**CONTRACT DOCUMENTS  
BOONE COUNTY, MISSOURI  
BID #45-29JUN06 Lake of the Woods Pavement and Drainage Improvements-Phase II**

**ADDENDUM #1  
(Issued June 21, 2006)**

P.C.C. PAVEMENT

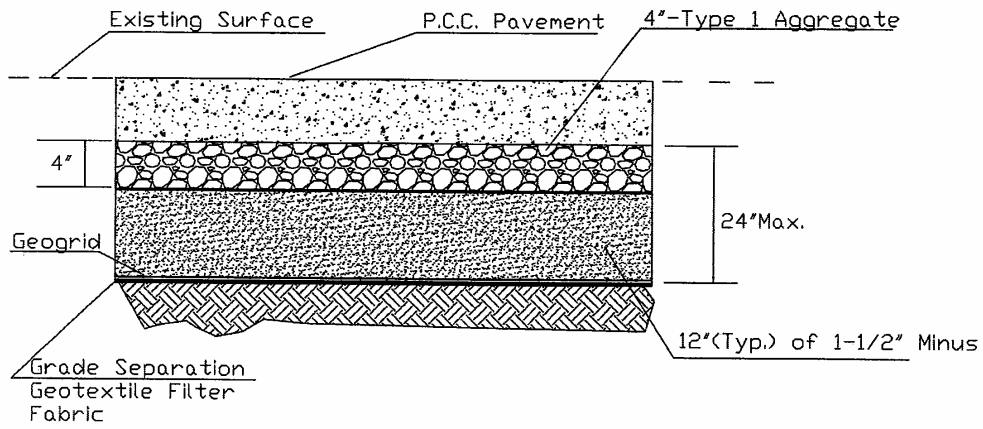
2. The attached detail sheet, which is part of this addendum, shall be used for the pavement and base repairs details.
3. On page 16.1 in SPECIAL PROVISIONS of the Bid Documents add the following statement: "The contractor shall not proceed with work adjacent to Yosemite until the sanitary sewer line is relocated. The contractor shall coordinate with the sanitary sewer contractor for the schedule of the sewer line relocation."

1. DEPTH SHALL BE A MAXIMUM OF 24' OR TO APPROVED SUBGRADE, WHICHEVER COMES FIRST.
